***Subject: 3rd Review Completion Letter  
 Koneru Short Plat, File No. SUB21-008  
 PACE Project No. 21436***

Subject: **Response to Request for Information #3 for File No. SUB21-008**  
Proposed Koneru Short-Plat  
6610 East Mercer Way  
Mercer Island, Washington

Subject: **Responses to Geotechnical Third-Party Review Comments**  
Proposed Short-Plat and Property Redevelopment  
6610 East Mercer Way  
Mercer Island, Washington

Attachments – NovoLIQ Output

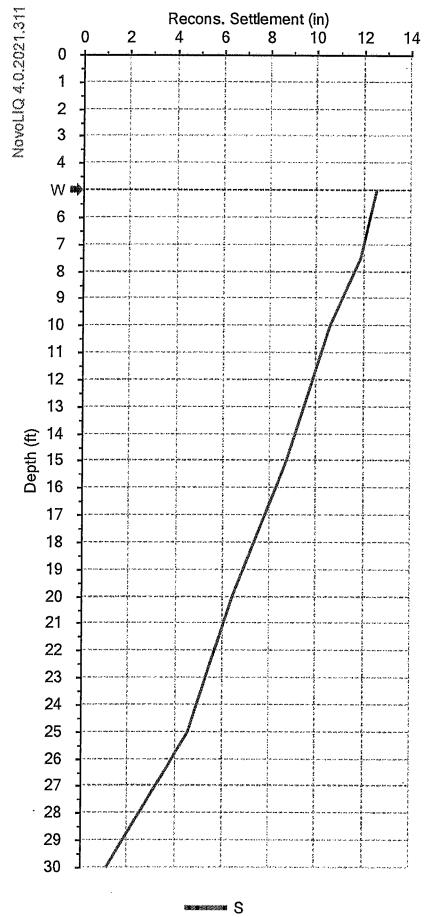
*1. To what depths will the liquefaction occur?*

*2. What will be the impact of this liquefaction? What magnitude post-liquefaction settlement is estimated? Provide calculations to support estimated settlement.*

**Response:** From previous experience, as well as liquefaction analyses we have conducted previously in similar soils, we know that it at least partial liquefaction beneath the site and surrounding area is possible during the Maximum Considered Earthquake (MCE) with a 1-in-2,475-year probability. This liquefaction could occur between the groundwater table (5- to 7-foot depth) and the dense soils, which were found at an approximate depth of 30 feet. Considering the variability in the gradation of the alluvial soils, it is most likely that liquefaction would occur within the saturated layers of sand and silty sand, which are interbedded with silt, typically thought to have a low potential for liquefaction.

In order to respond to these review comments, we utilized NovoLIQ to confirm that liquefaction of the soil underlying the water table is likely to occur in the low-probability MCE. The results of our liquefaction analyses are attached.

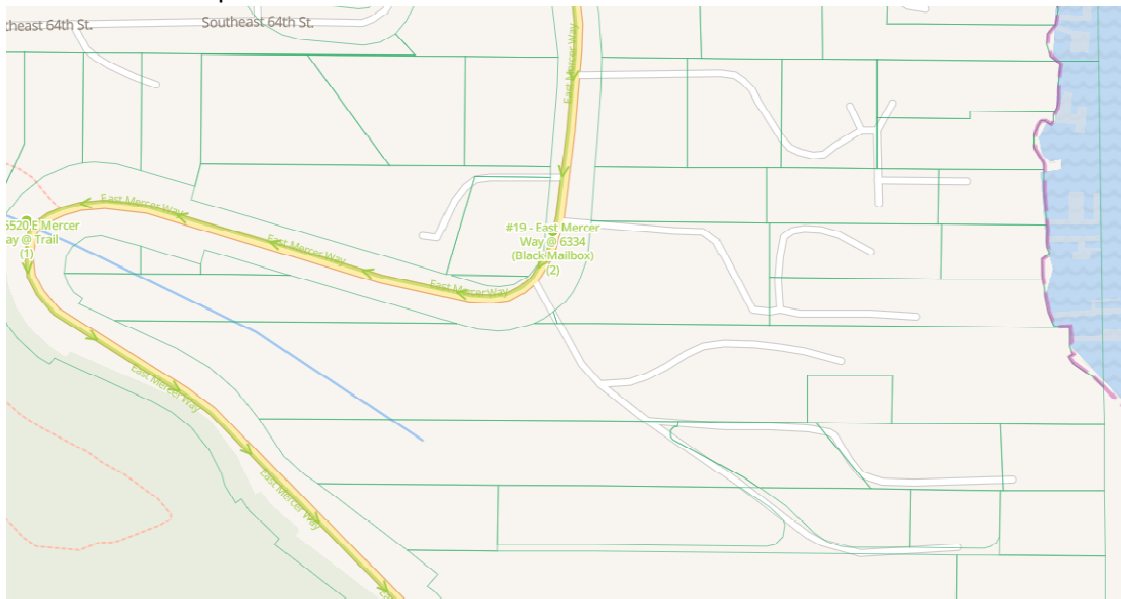
- 
2. In the last comment review letter, the City requested the Applicant provide an analysis of school bus stops or safe walking routes to schools. The applicant did not provide an analysis of school bus stops or safe walking routes to schools, nor did the applicant coordinate with the school district on bus stop locations that will serve the proposed development. The Applicant shall provide the analysis and approval from the school district at the next submittal.

***PACE Response: The school bus stop location was discussed with Mr. Patrick Rock of the Mercer Island School District. Mr. Rock said the pickup location would be near the mailbox stand at the private driveway intersection with East Mercer Way. Mr. Rock provided an email that includes the district's map of the pickup location, see attached email.***

This is the bus stop for that location.
